PLAN AND ZONING COMMISSION MEETING

CITY OF DAVENPORT, IOWA

Case F21-08: Request of S.J. Russell, L.C. on behalf of Sophie Foster Revocable Trust for a Final Plat of Birchwood South First Addition for a 6-lot subdivision on 17.92 acres located at 4607 East 53rd Street. [Ward 6]

Case F21-09: Request of Dan Dolan Homes on behalf of Sophie Foster Revocable Trust for a Final Plat of Birchwood Grove for a 15-lot subdivision on 20 acres located at 4607 East 53rd Street. [Ward 6]

P:\Projects\MO\3204340\Deliverables\Drawings\1a_Survey\B101 Final Plt.dwg

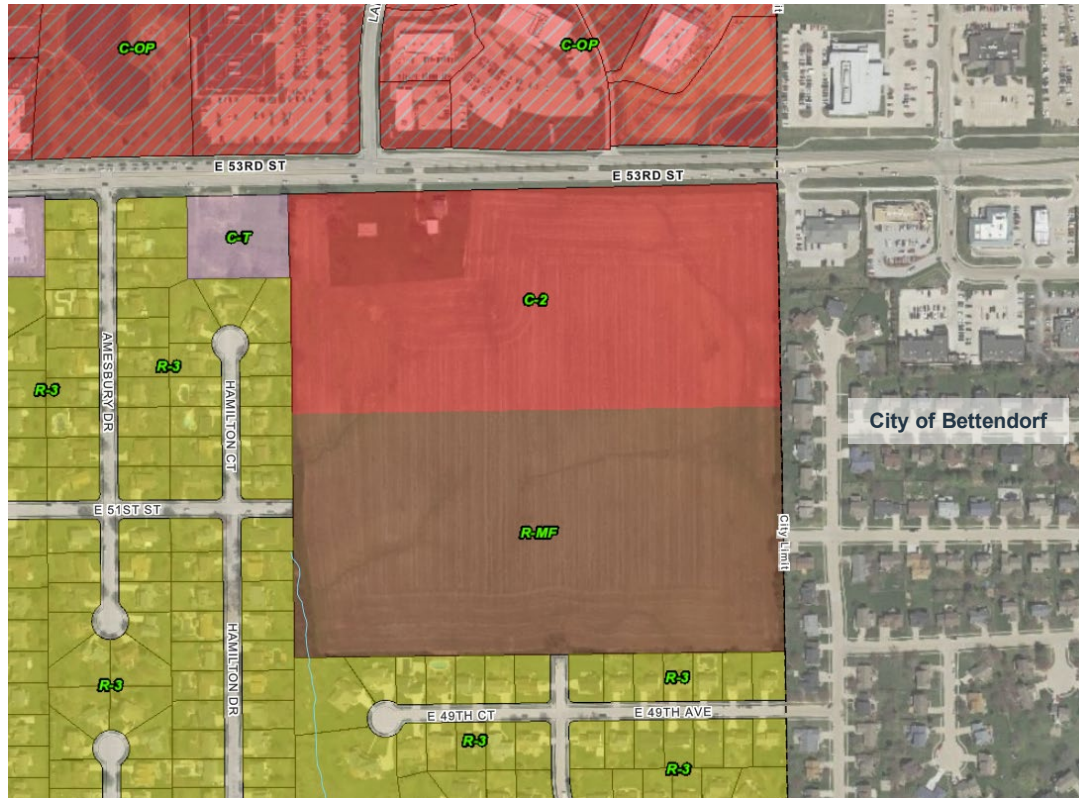
Remove 'Zoning' note #2 and #3.

Under the 'Zoning' notes, list the following rezoning conditions from Ordinance 2021-105:

The 15' easement that runs on the north should contain the word "sewer" in the description.

All easements that contain public sewers should include in the description, "sewer". Even though they're in the ROW, update the easement on the south of E 52nd to include "sewer" in the description.

All curves also need the central angle shown.

Add Metro Link signature block.

Add a 15' utility easement on the north side of 52nd Street.

Add Metronet as a utility signatory.

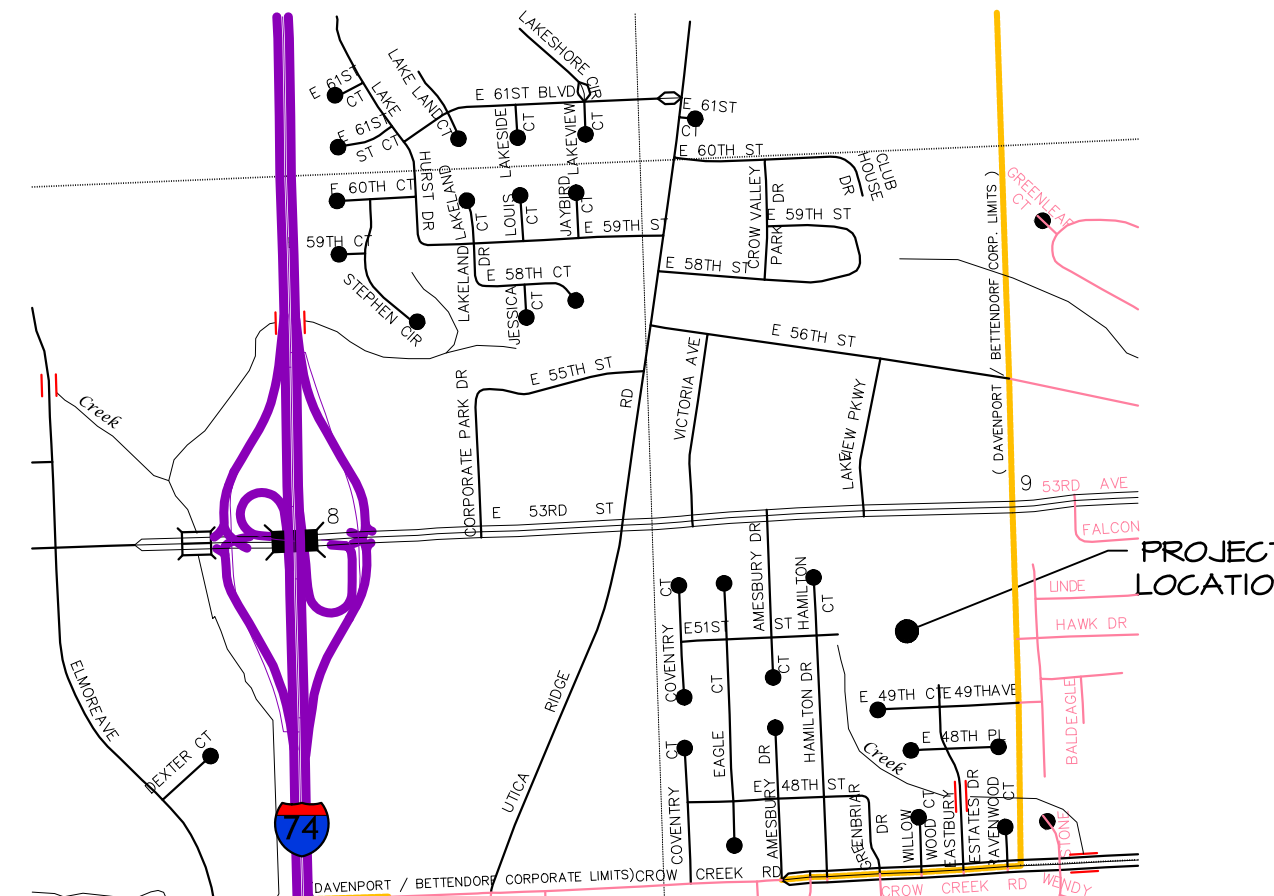
Include a note stating, "The 30' landscape buffer shall be planted prior to the issuance of any certificates of occupancy."

Revise Note #4 to state, "The height of structures in the R-MF zoning district shall be no greater than 35 feet."

Add a note stating, "Upon vacation by the City of a portion of Eastbury Estates, Petitioners, jointly and severally, shall be responsible for paying for or executing the work specified by the City of Davenport for reconfiguring/redesigning/reconstructing the northern terminus of Eastbury Estates in the area abutting the southern boundary of the subject property. The City is to provide plans, including a site plan and landscaping plan to Petitioners."

General Note 10: Add to the last line, "or so order by the City of Davenport."

The proposed sanitary sewer, "SA12" from the plans, at the south of lot B there will need to be at least 7.5' from the sewer to the property line or an additional easement will need added to lot C. The other option would be to move SA12 slightly north.

Remove Survey Notes Nos. 2 and 3.

The "Land Description" is not needed on the plat, removal would provide less clutter.

PRELIMINARY PLAT

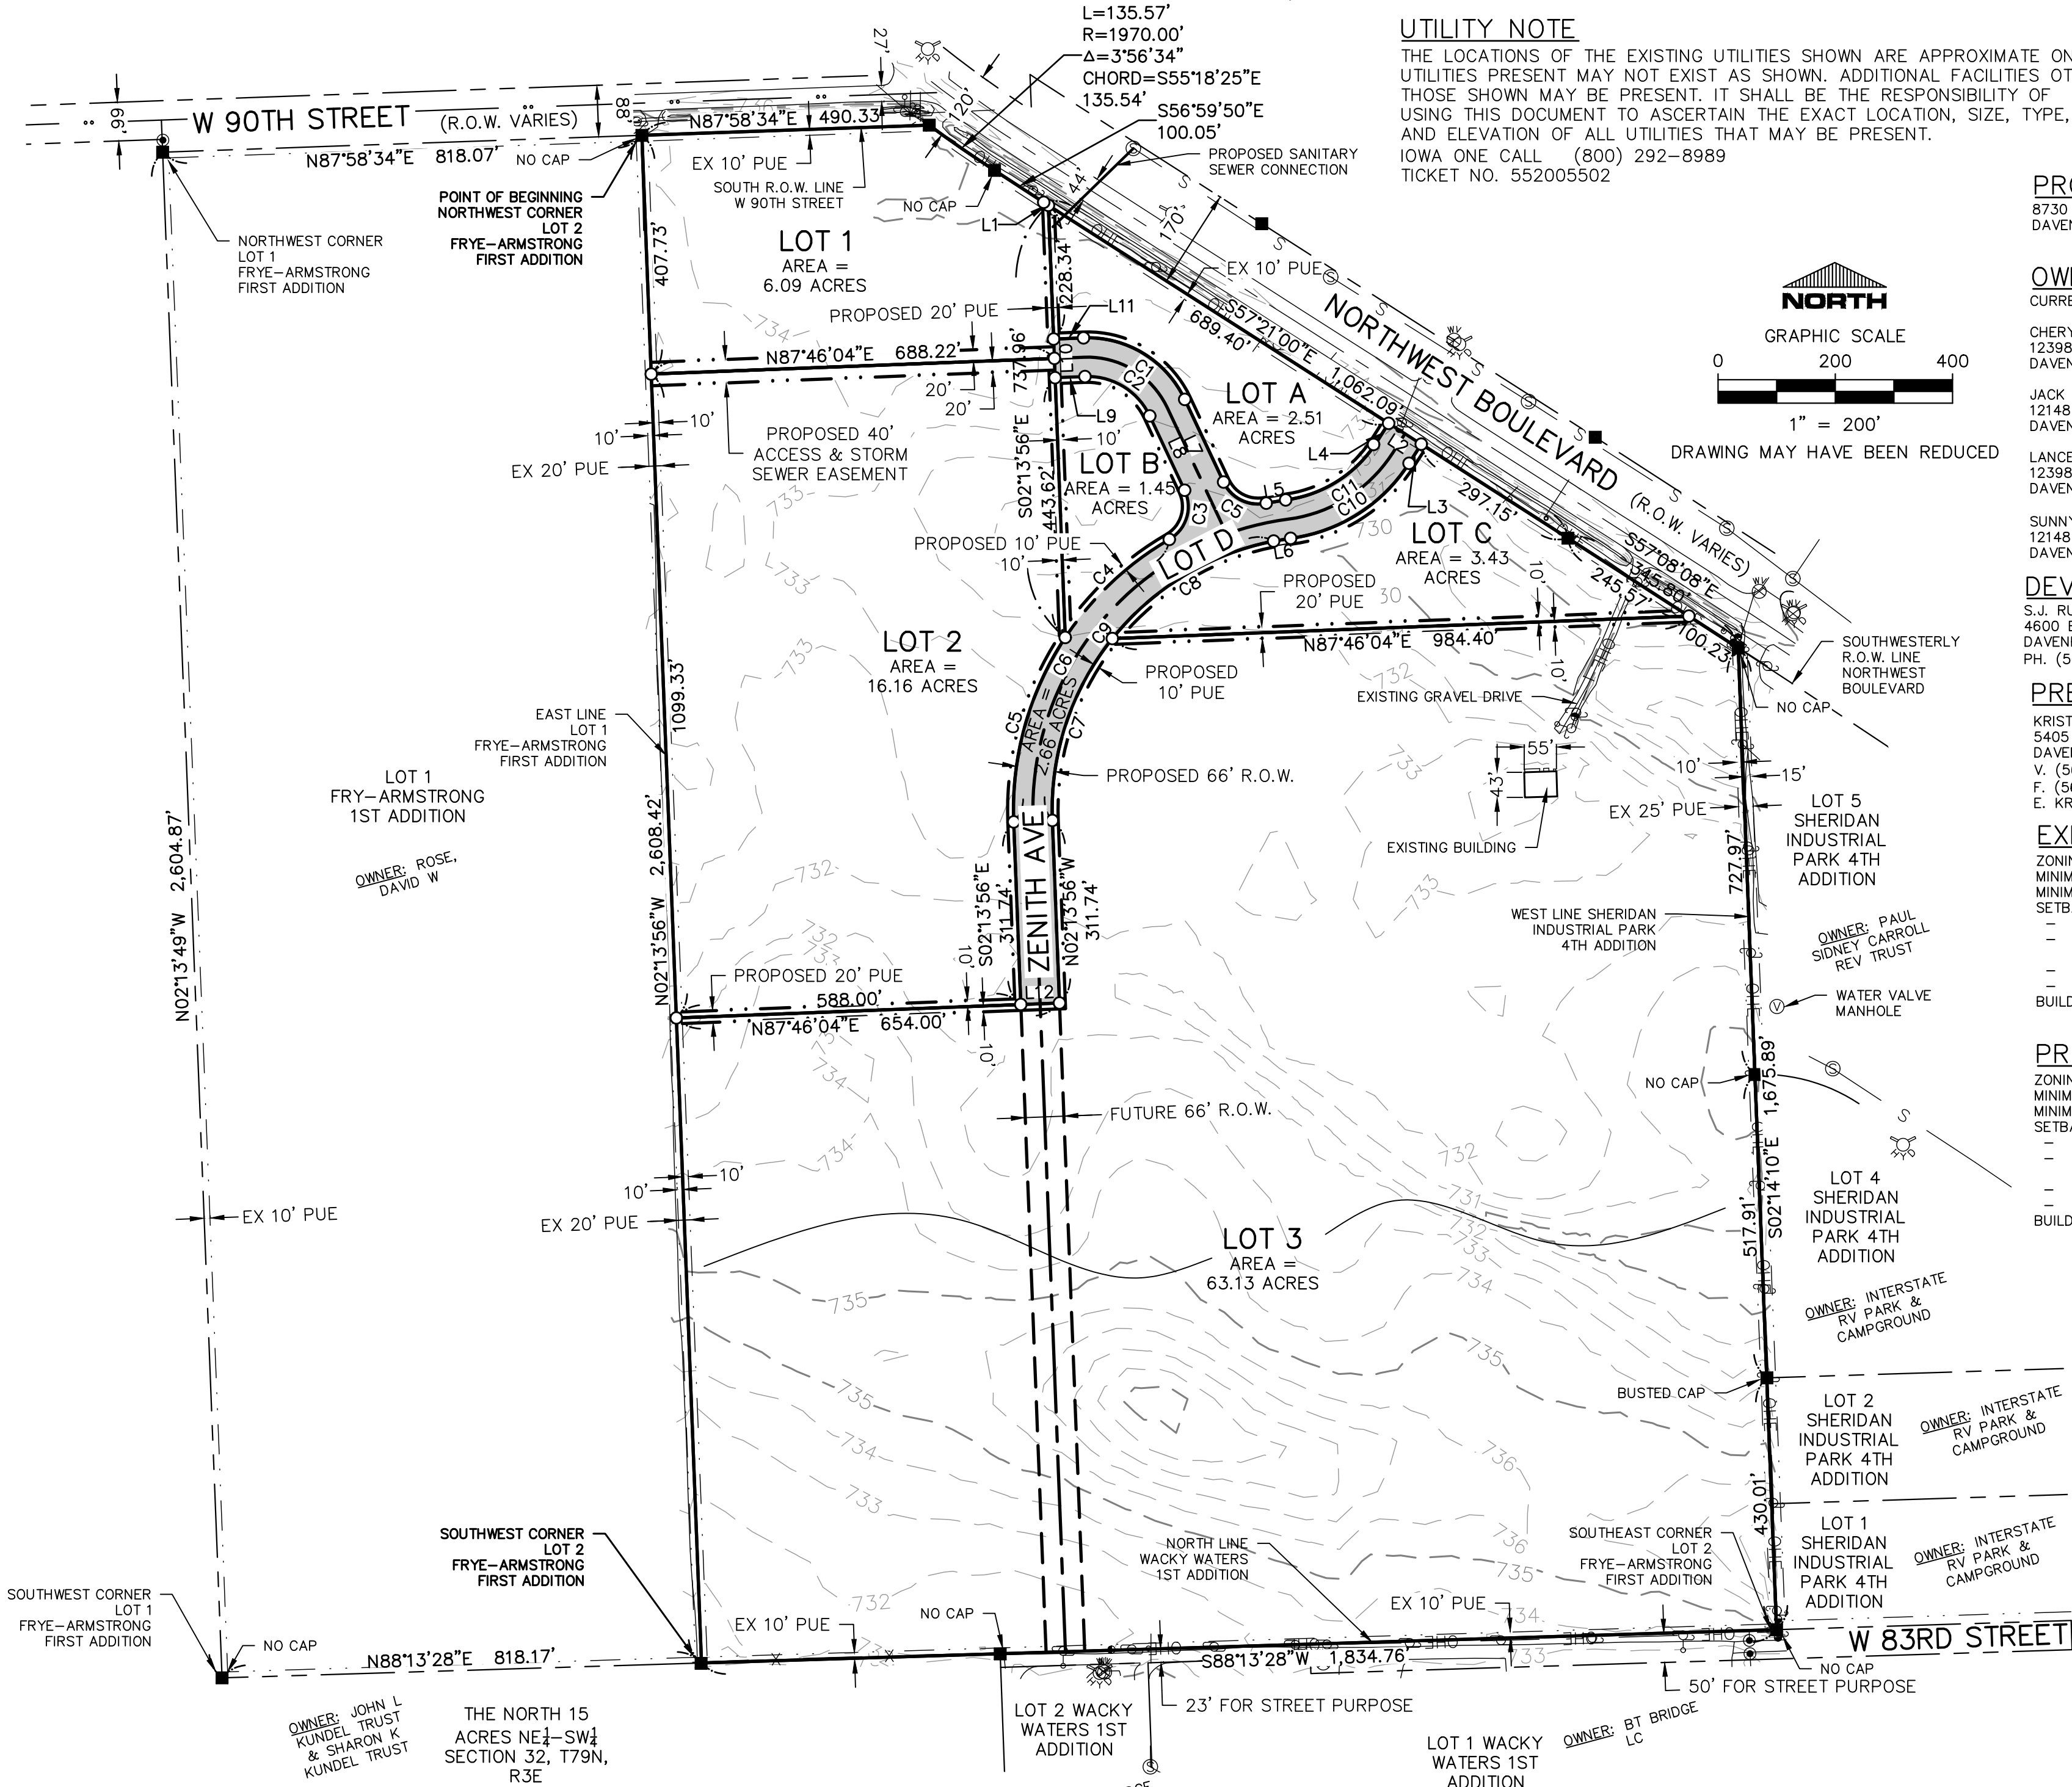
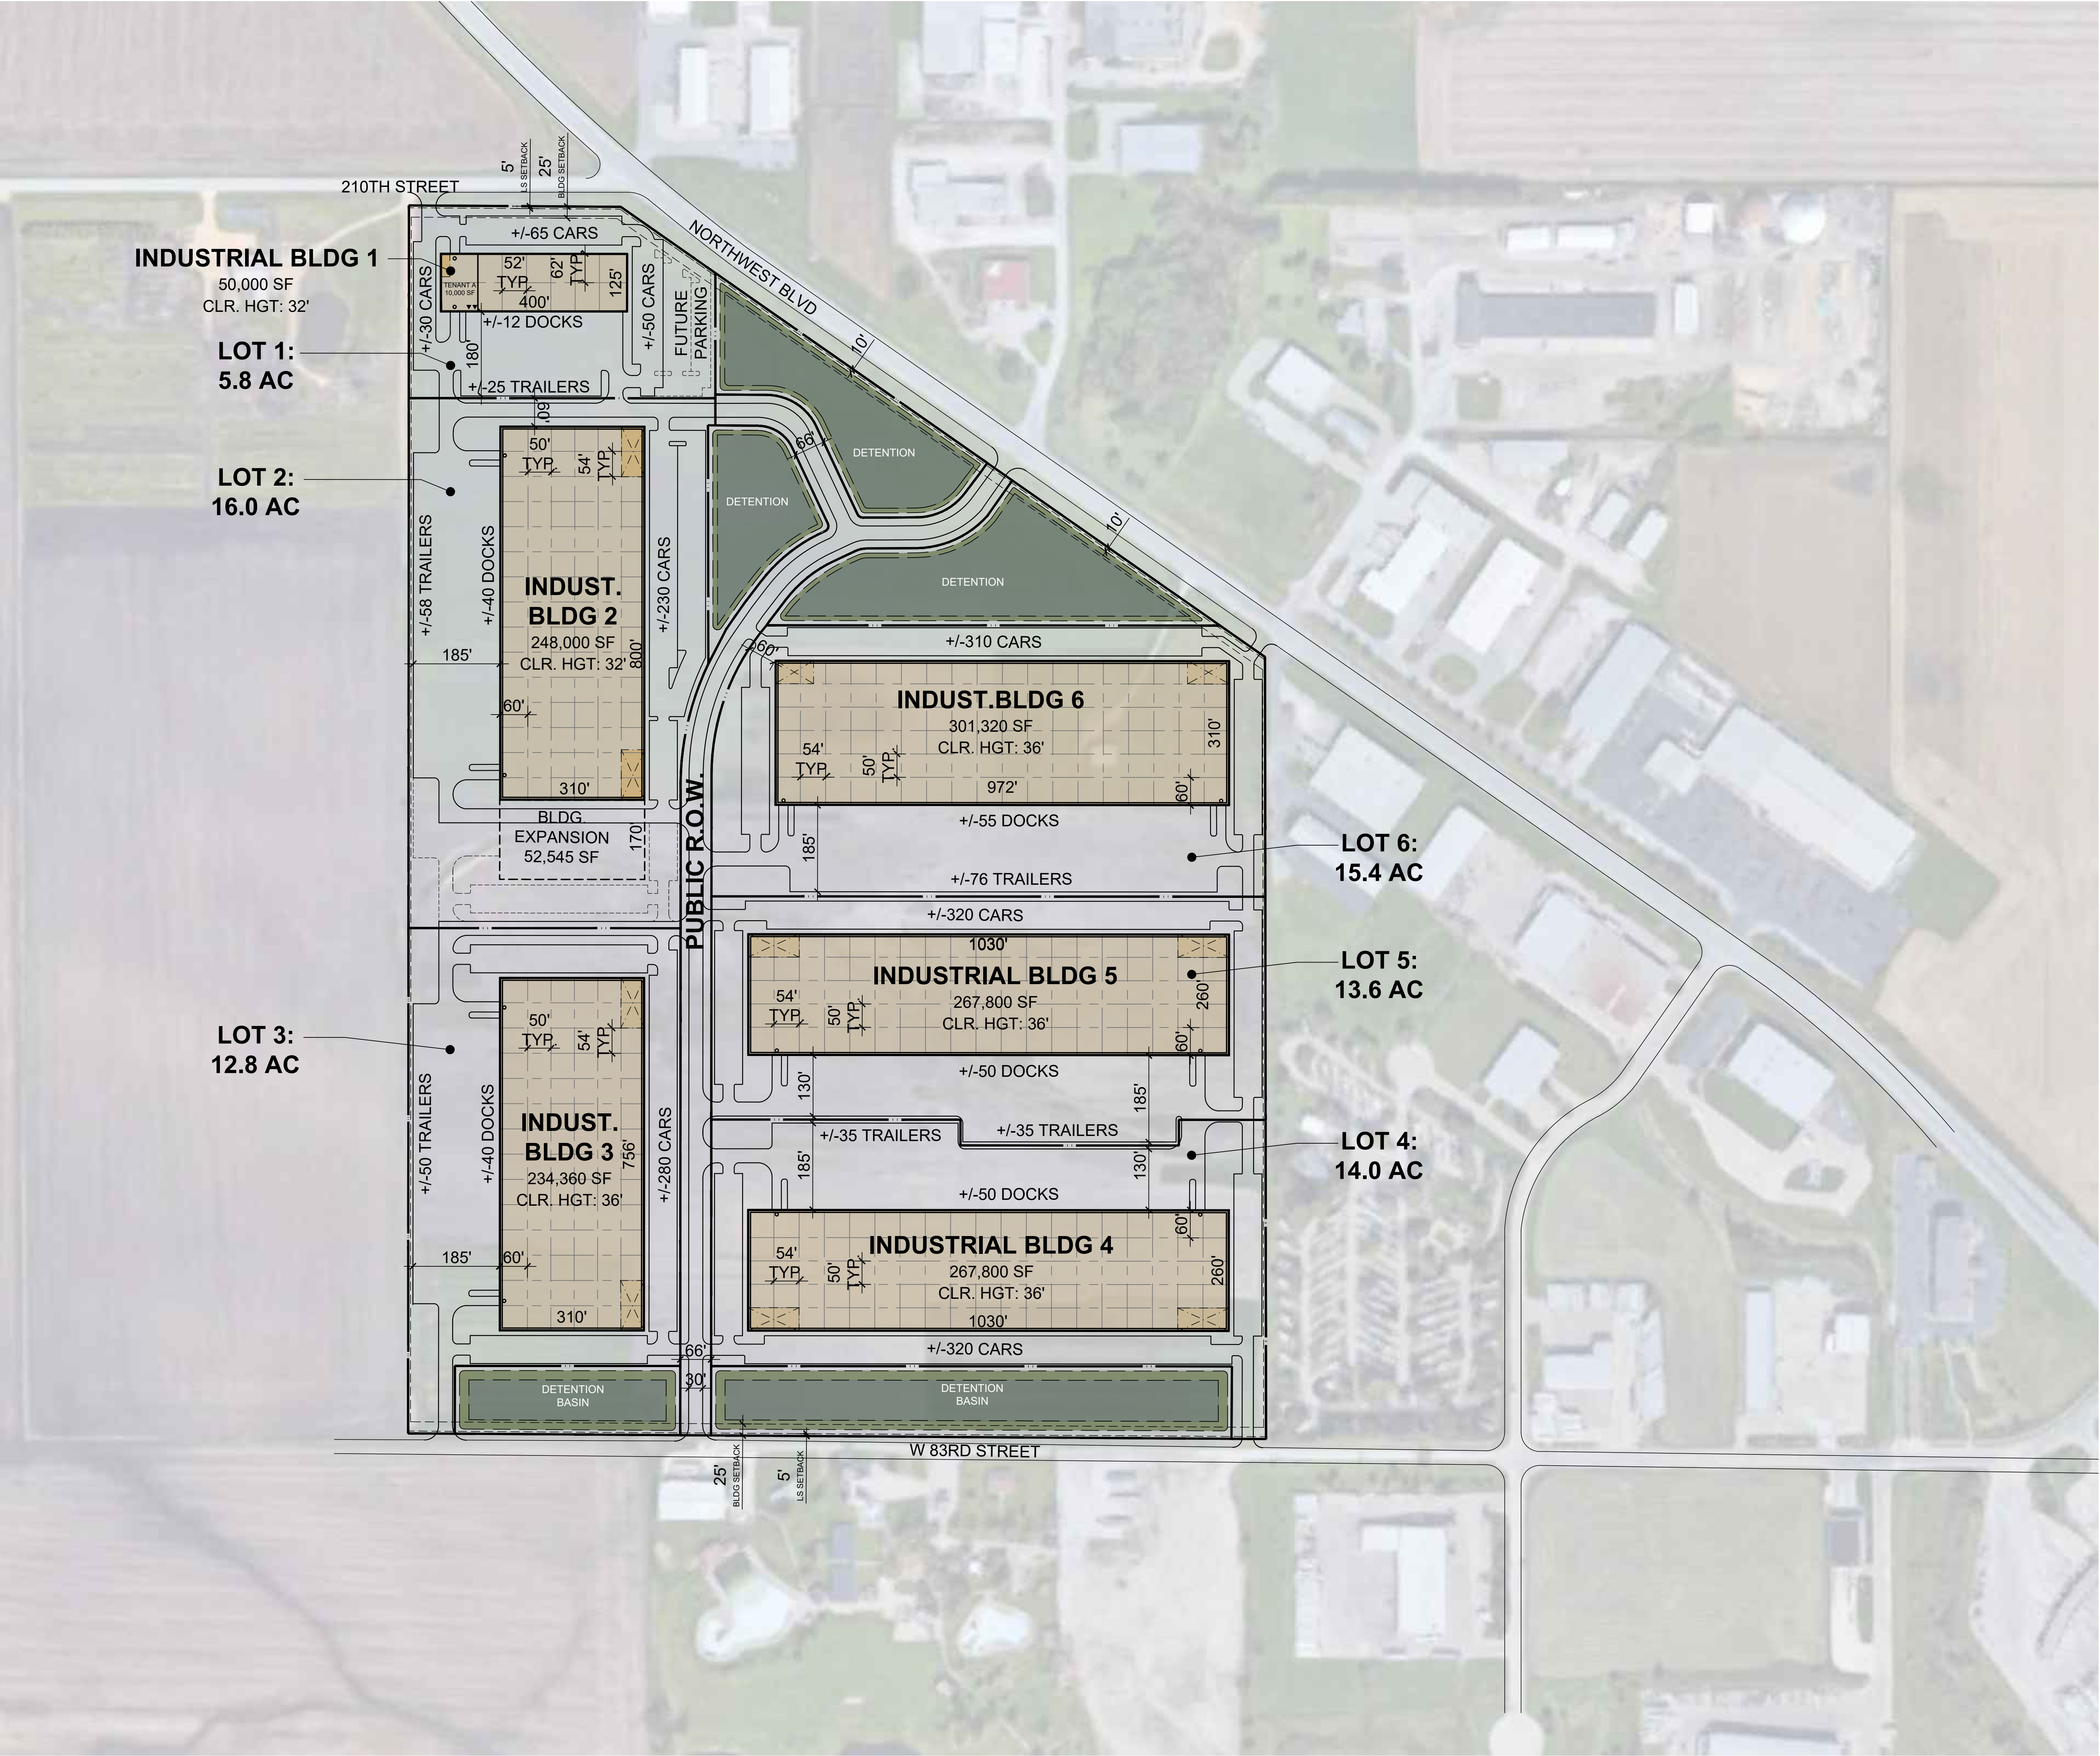
1. An additional 20 feet of Utility Easement shall be added to the existing 10 foot easement along the south lot line.
2. All sewer easements shall be either 15 feet wide or twice the depth of the sewer, whichever is greater.

5. Standard Plat Notes shall be added.
6. Corporate limits shall be shown on the plat.
7. Lot three shall not have any direct access to Northwest Boulevard.

8. Additional storm and sanitary sewer easements shall be required based on preliminary engineering of conceptual plans including service drainage of the property to the west.

9. Provide 30 feet of right-of-way radii at the intersection of Northwest Boulevard & Zenith Avenue.
10. Lots A, B, and C shall be labeled as outlots and shall be shown with stormwater detention easements.
